## SCHEMATIC REVIEW - APPROVED

RE: QUIZNOS SUB  
Meridian Crossroads Store #11329  
Highway 19 and I-20 Shop 204  
Meridian, MS 39301  
(Accepted 04/16/07)

#11329 SCHEMATIC

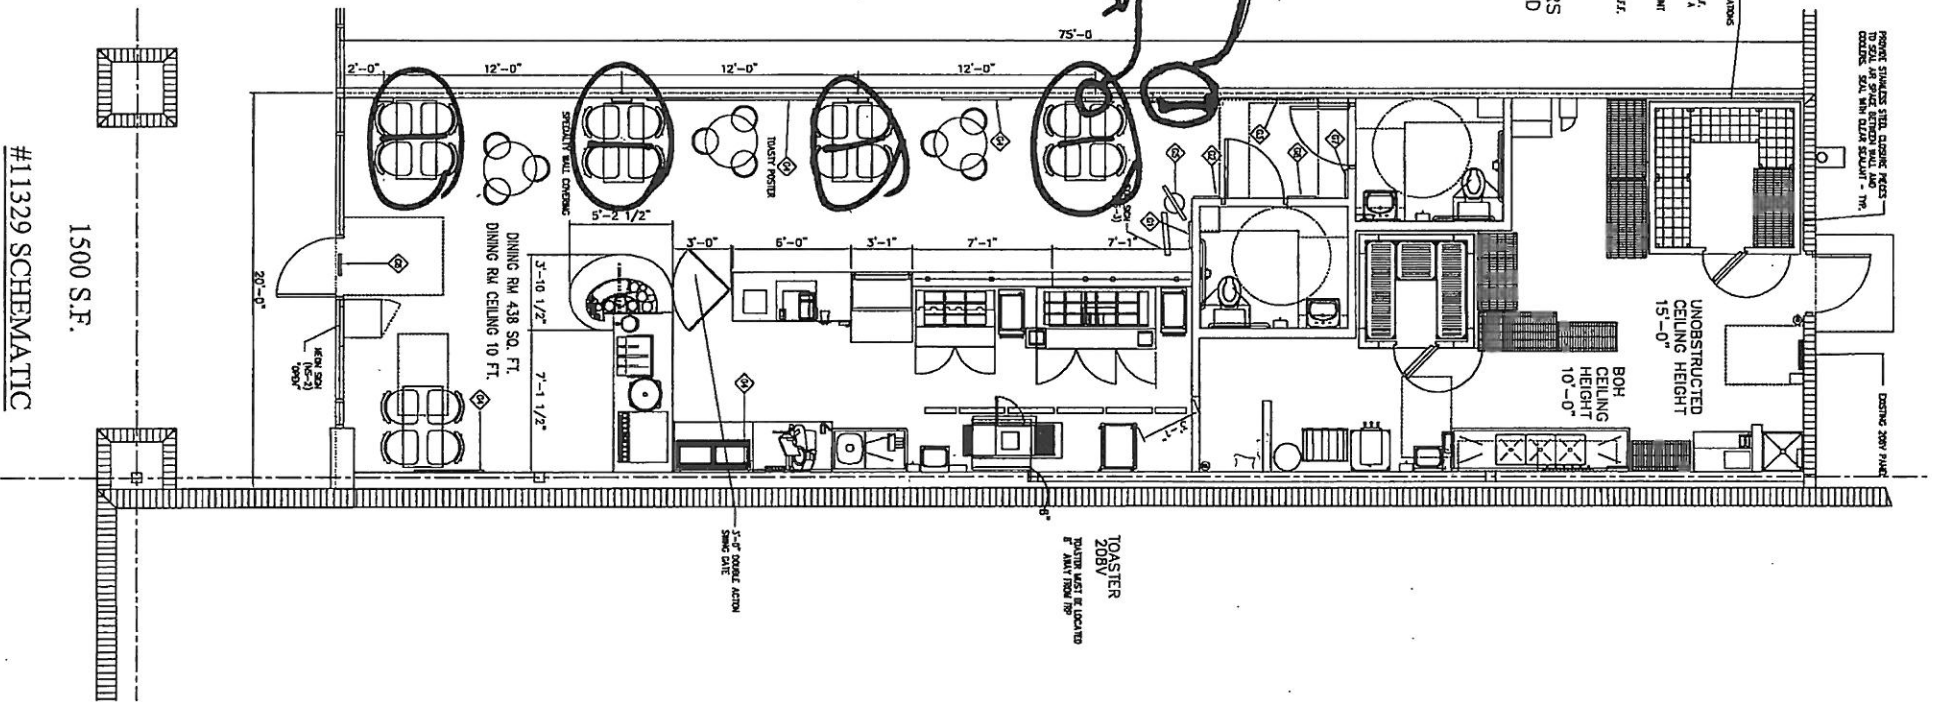
- a. Only one 4-top is allowed. Change others to 2-tops.
- b. Artwork package comes with 5 posters. Please show as many as design will allow.
- c. Remove 4<sup>th</sup> pilaster.

- a. Suggest a more even ratio of round and square tables. Only what is shown will be ordered.

- g. Remote compressors noted per the schematic. Verify.
- h. A 9'-6" high freezer is noted. Please complete the Kolpak worksheet and return it to our office. Construction documents will not be reviewed until the Kolpak worksheet has been received by the design and construction department.

- i. A 208V toaster is noted and will be ordered unless otherwise specified. Verify.
- j. Effective immediately- Place the toaster 6" to 8" away from the FRP to prevent the FRP from melting due to high temperatures from the toaster. \*\*\*Verify the clearance of the service area due to the toaster moving out 6" to 8".

SHOW POSTER

REMOVE 4TH PILASTER

THESE CANNOT BE 4-TOP TABLES. CHANGE TO 2-TOPS.
